ENVIRONMENTAL IMPACT REPORT

123 MISSION STREET OFFICE BUILDING

FINAL 81.183E

DRAFT EIR PUBLICATION DATE: MARCH 4, 1983
PUBLIC HEARING DATE: APRIL 14, 1983
PUBLIC COMMENT PERIOD: MARCH 4 TO APRIL 22, 1983
CERTIFICATION DATE: JUNE 30, 1983

FIGURE 12: VIEW OF THE SITE FROM THE NORTHWEST CORNER OF MISSION AND MAIN STREETS

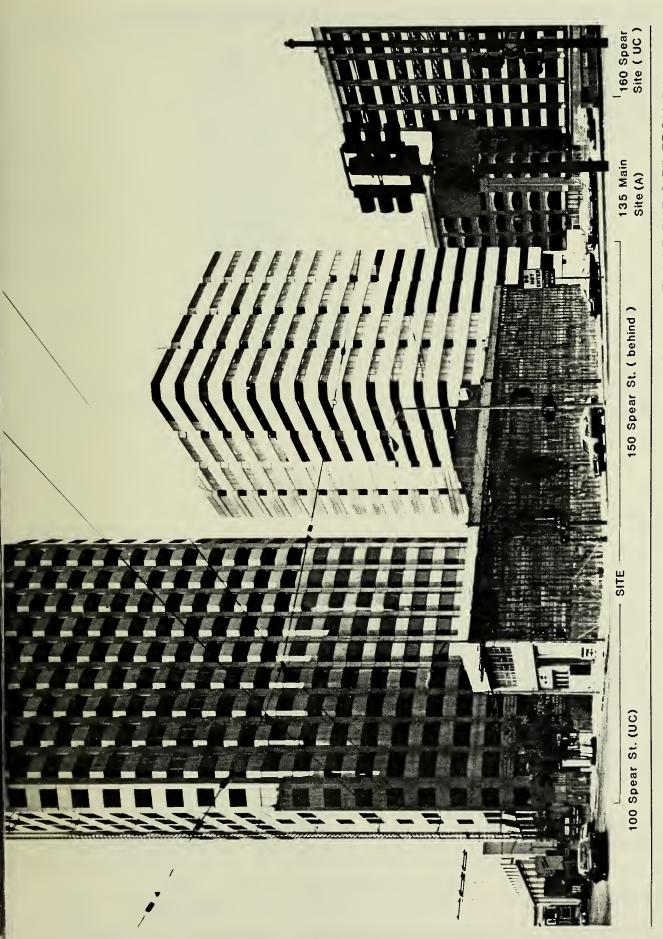
The photograph on p. 24 of the EIR (Figure 12) has been replaced with a photograph of the site taken on June 3, 1983. Figure 12 is included here as p. 136.

FIGURE 24: SHADOW PATTERNS -

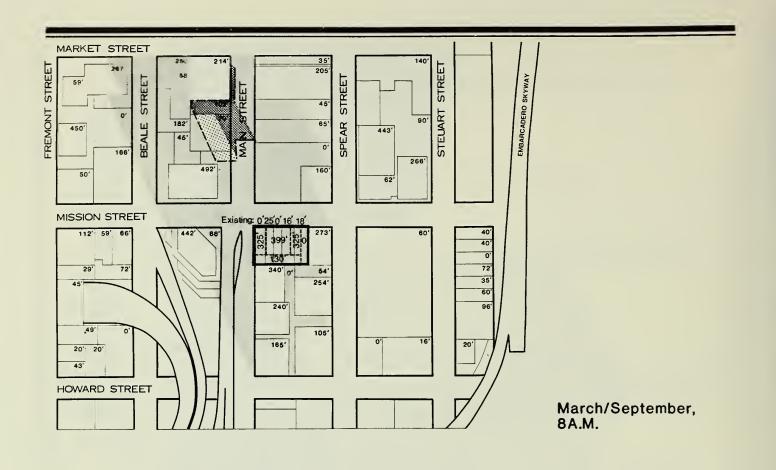
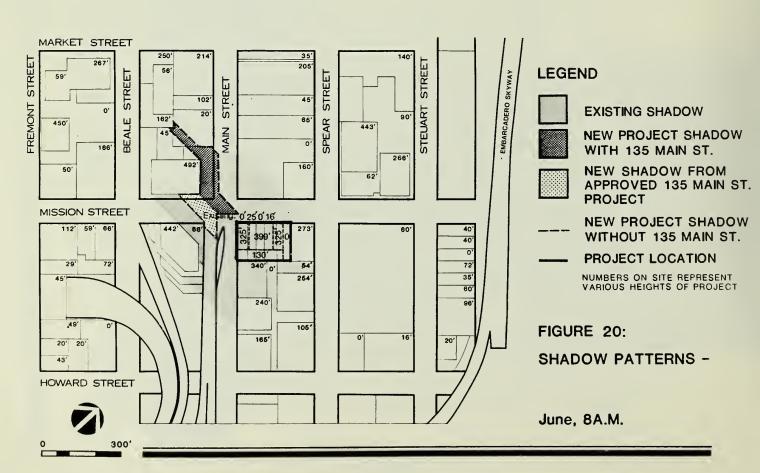
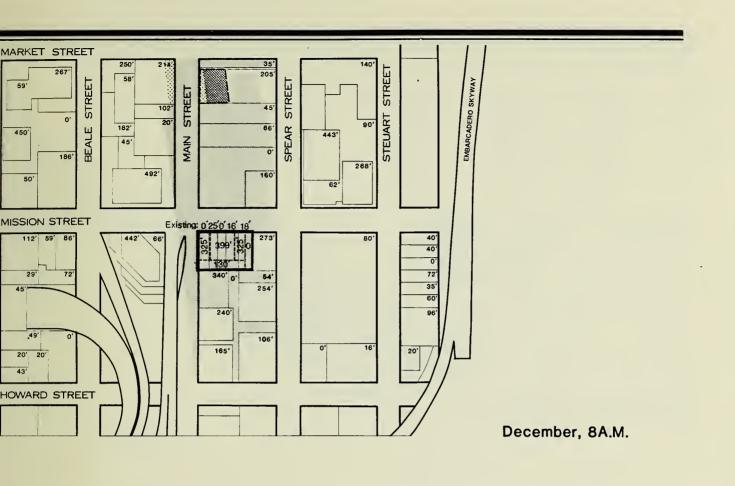
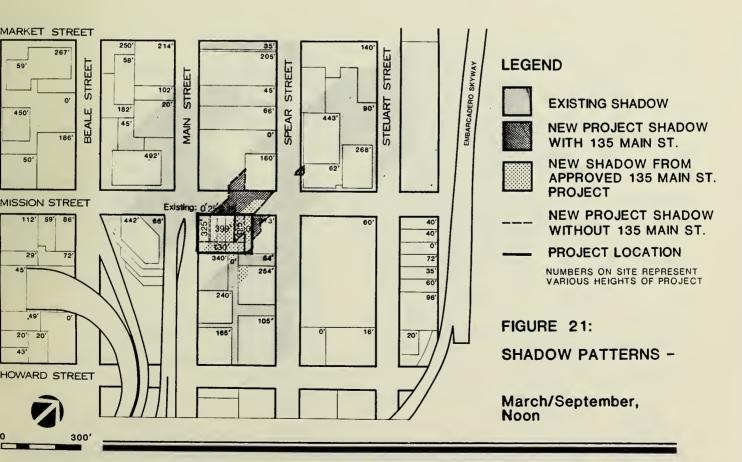
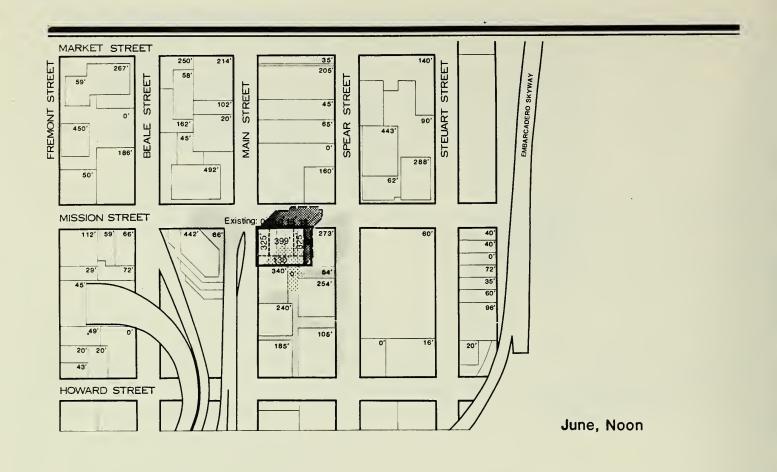
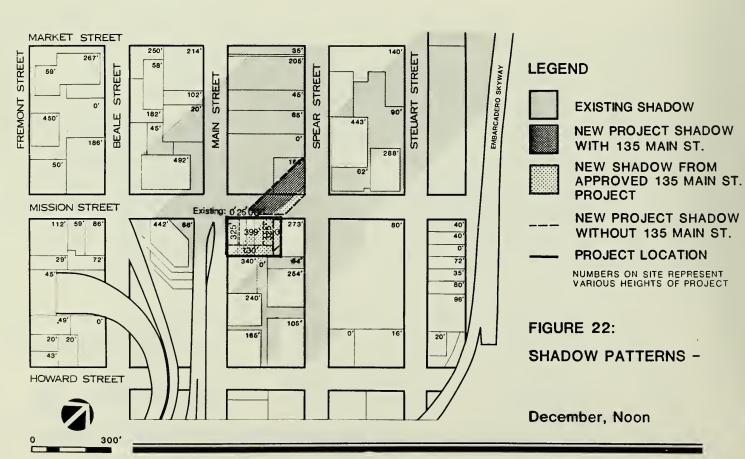
The legend on the shadow diagrams, Figures 20-24, pp. 57-61 of the EIR, has been clarified to clearly identify the 135 Main St. project. The diagrams have been revised to show only the new shadows from the 135 Main St. development. The revised shadow diagrams are included here on pp. 137-141. It should be noted that shadows shown as "new" for the 135 Main St. building are depicted as they would be if the 123 Mission St. project were not built. This is consistent with the fact that the

FIGURE 14: PARKING IN THE VICINITY

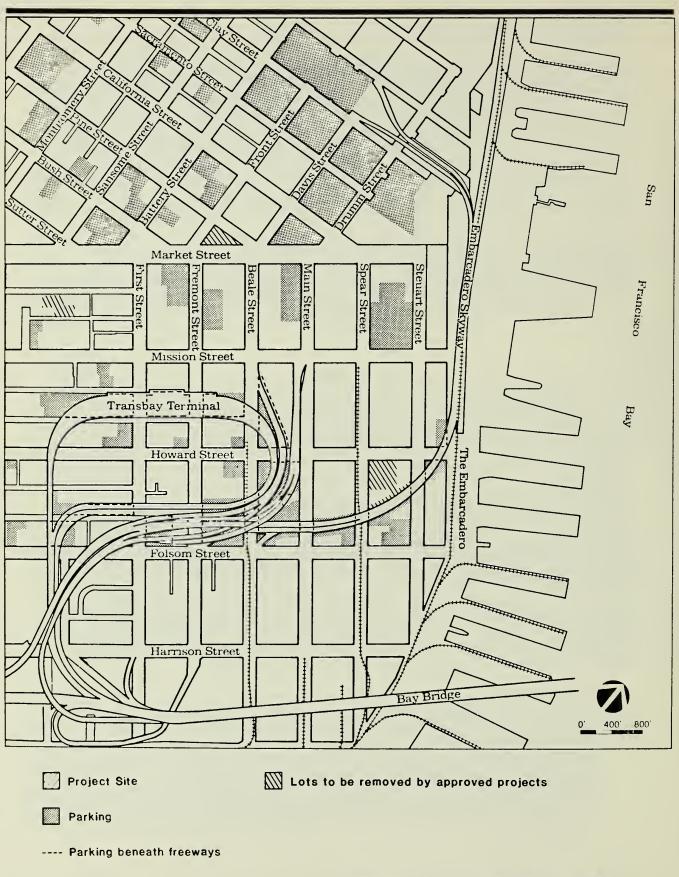
Figure 14 on p. 38 of the EIR has been updated to indicate those lots which would be removed by approved projects not yet built and which would be removed by proposed projects if approved. In addition, lots that have been closed due to projects that have begun construction since publication of the Draft EIR have been deleted from Figure 14. The revised figure is included here on p. 165.

● FIGURE 30: ALTERNATIVE 4 -SPONSOR'S PREFERRED ALTERNATIVE -ELEVATIONS

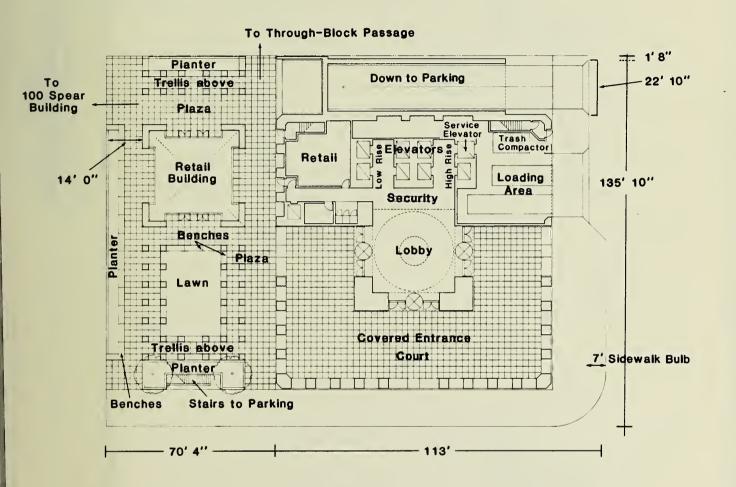
"The tower would be about 390 ft. tall, including the roof-top mechanical penthouse (see Figure 30, p. 175), with horizontal dimensions of 113 ft. by 113 ft. Clear glass would be used at the ground floor, with bronze-tinted glass at upper levels. The facade would be light-colored travertine with a darker travertine accent band. The mechanical penthouse level would be set back to emphasize the parapets at the four corners of the building. The mechanical and service core, located along the southerly property line, would be about 23 ft. wide and 75 ft. long. would be set in from the westerly building wall by about 18 ft. Entrance to the tower would be from a covered entry court with access to the plaza surrounding the one-story retail building. The retail building would be about 43 ft. wide in its horizontal dimensions. A landscaped area would be located before the retail building (see Figure 31, p. 176). Benches and planters would be located around the lawn. Benches and planters would be located on the southerly, easterly and northerly edges of the plaza, with trailing-vine- covered trellises on the south and north. The plaza would provide access to the mid-block pedestrian passage and to the 100 Spear St. building to the east.
